**TOWN OF COTTAGE GROVE
TOWN BOARD
RESOLUTION 2024-11-06a**

**GRANTING CONDITIONAL APPROVAL OF THE
PRELIMINARY PLAT OF KENNEDY HILLS FIRST ADDITION**

PRELIMINARY PLAT OF KENNEDY HILLS FIRST ADDITION

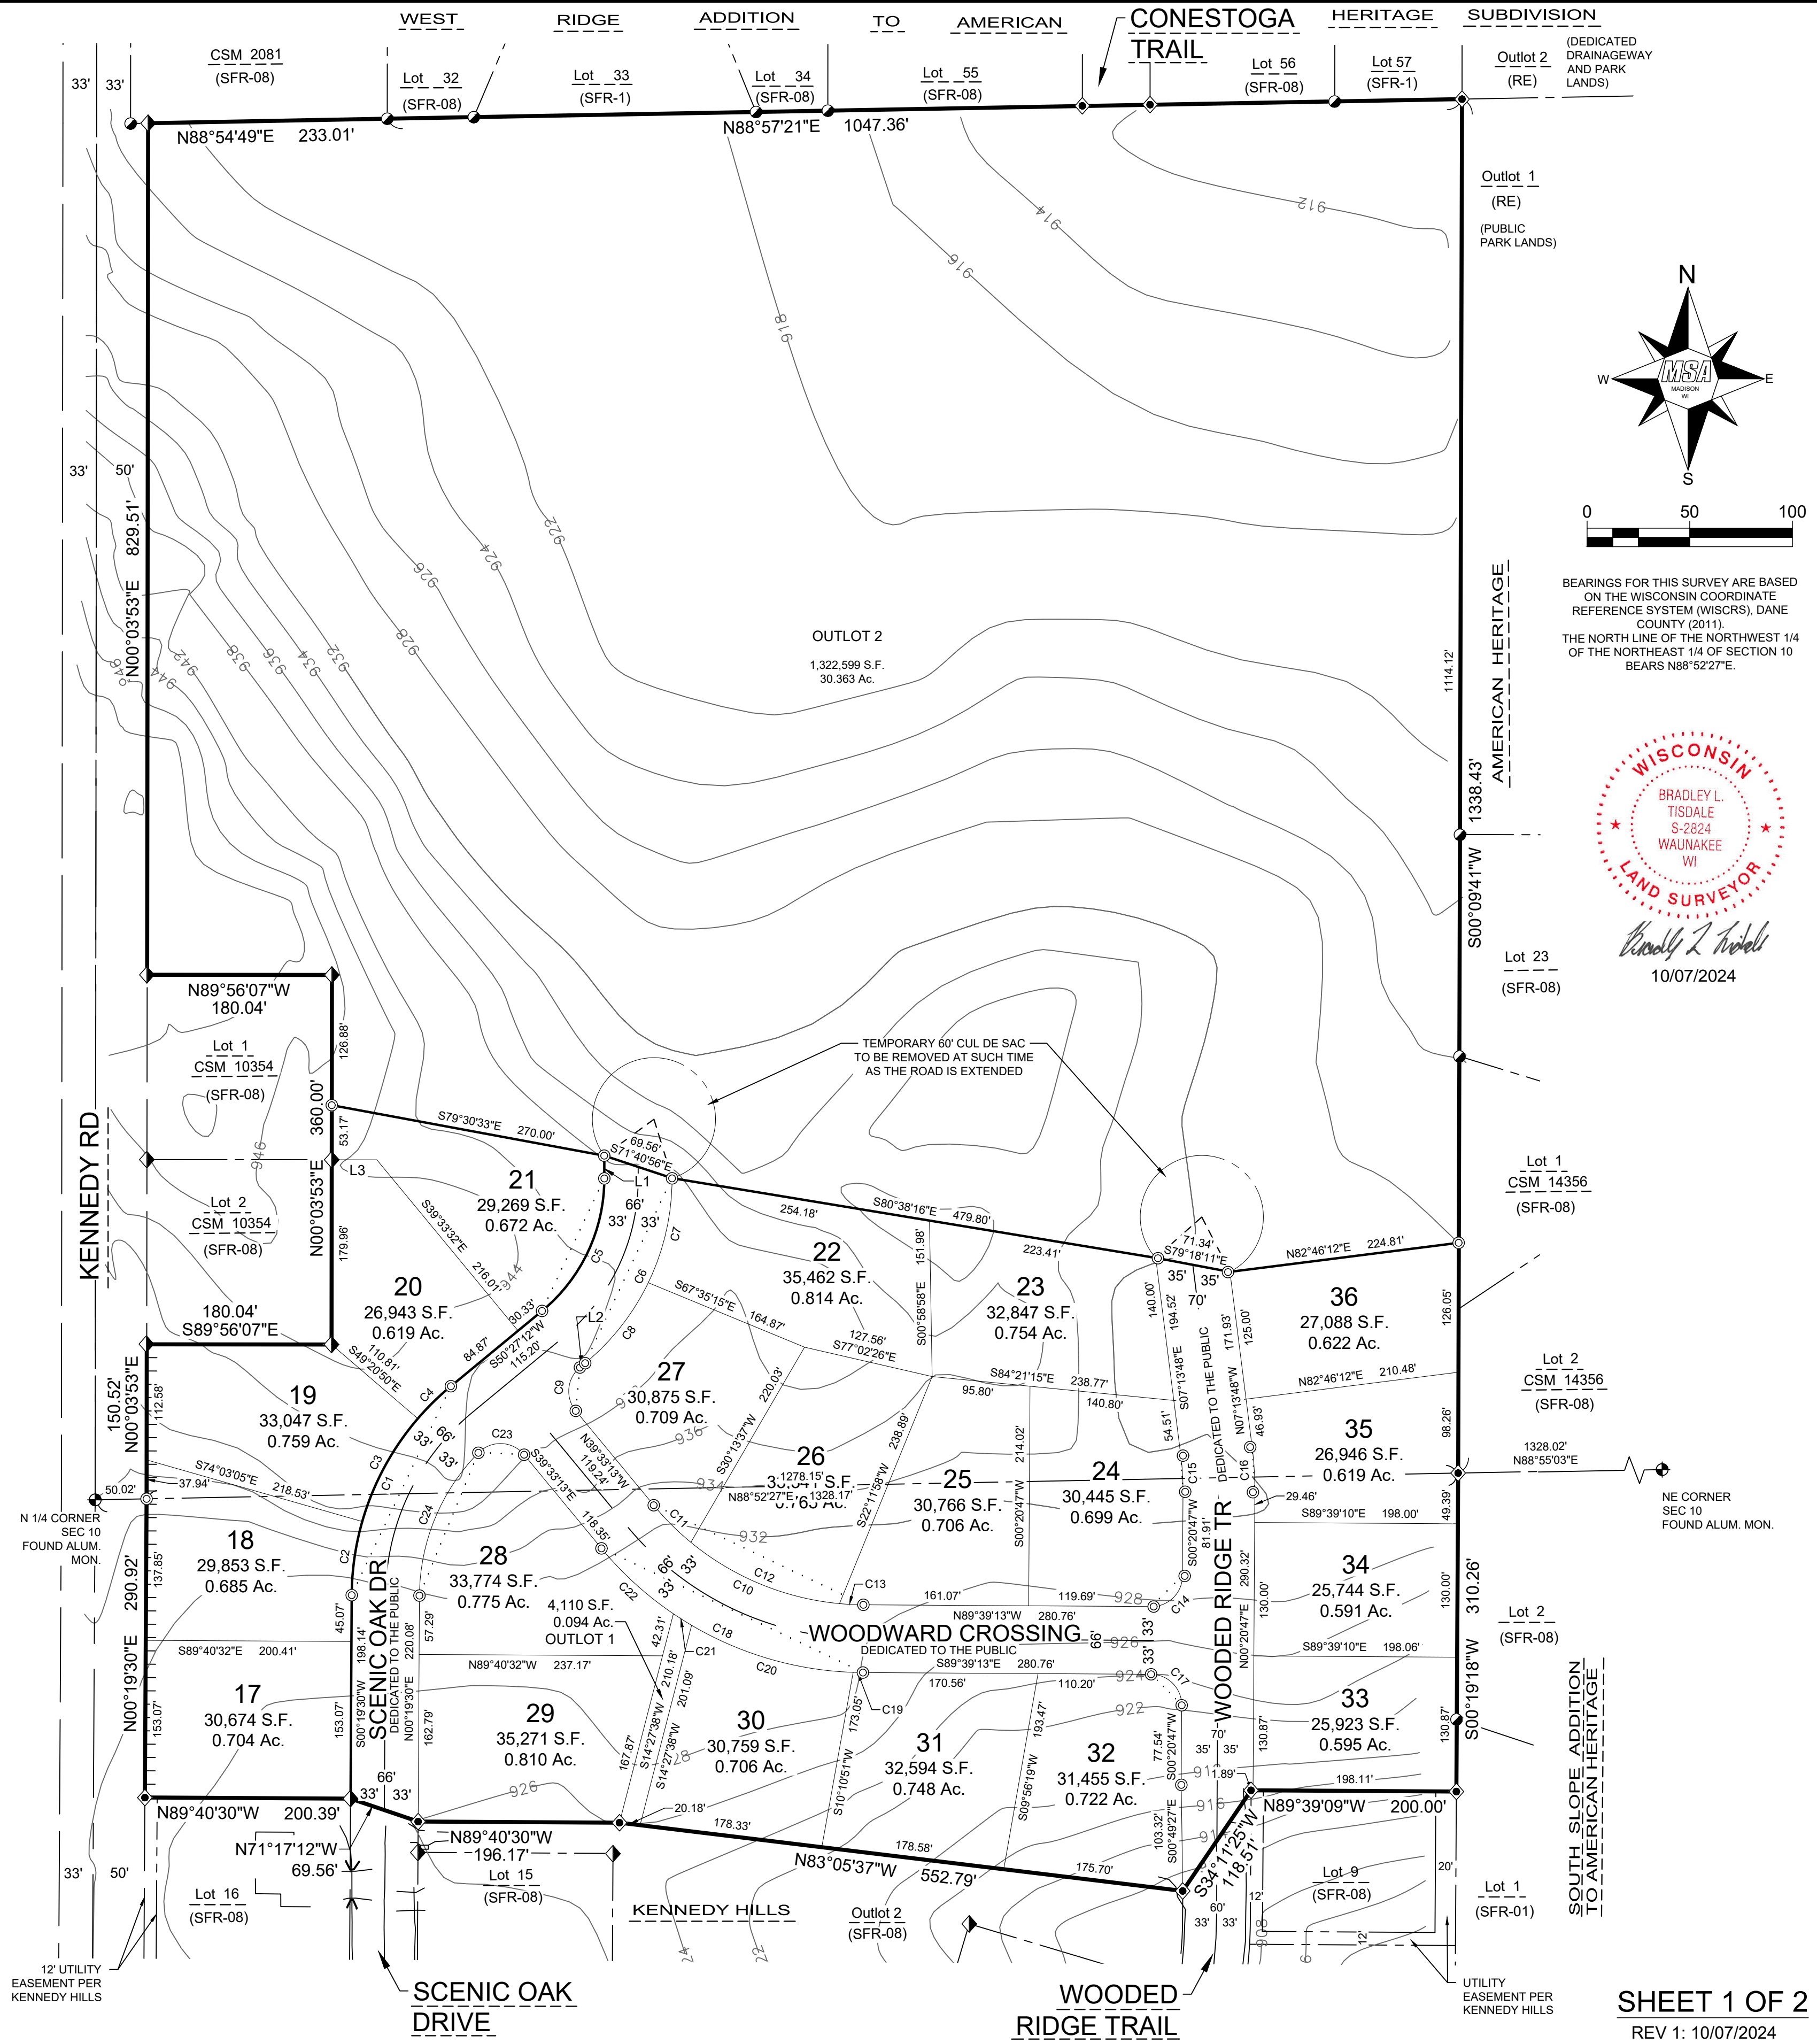
- i. The Developer shall replace on the preliminary plat and engineering plans the current cul-de-sac bulb at the northern terminus of current Wooded Ridge Trail with a hammerhead turnaround within the dedicated right-of-way, of a design approved by the Town Engineer.
